Item Name: Comfort Crew Shoulder Harness

DART SERVICE INSTRUCTION

TO AMEND IIN-D412-702-3 REV. A OR EARLIER

THE PURPOSE OF THIS DSI IS TO CORRECT THE HARDWARE CALLED OUT IN THE D412-702-071 KIT.

FIGURE 25.18 DART D412-702-071 PILOT/CO-PILOT SHOULDER HARNESS KIT (REF: ICA D412-702)

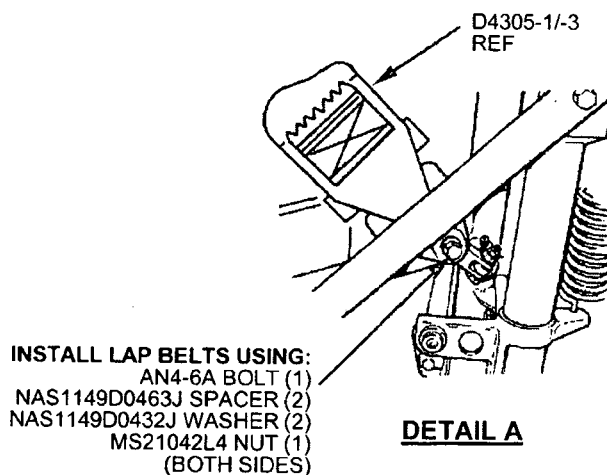
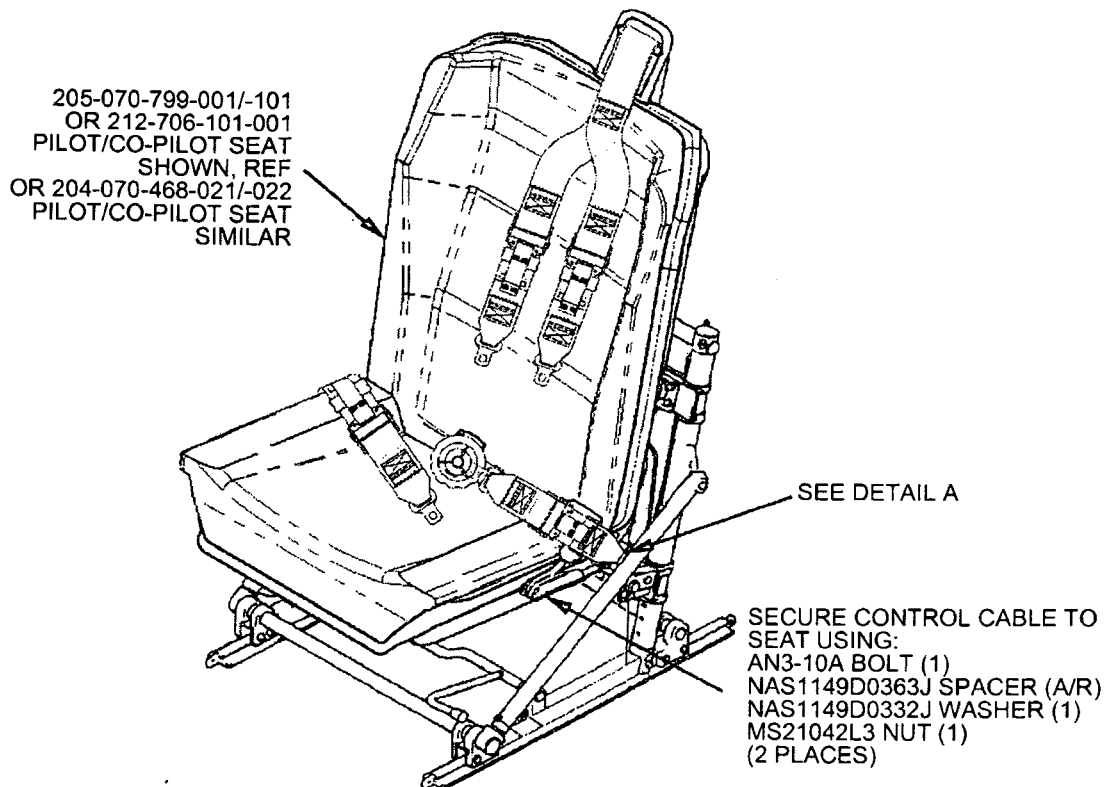
4.0 CHANGES

QTY -071	P/N	DESCRIPTION
X	D412-702-071	DART PILOT/CO-PILOT SHOULDER HARNESS KIT
1	D4305-041	SHOULDER HARNESS
4	AN3-4A	BOLT
2	AN4-6A	BOLT
2	AN3-10A	BOLT
6	MS21042L3	NUT
2	MS21042L4	NUT
10	NAS1149D0332J	WASHER
6	NAS1149D0363J	WASHER
4	NAS1149D0432J	WASHER
4	NAS1149D0463J	WASHER
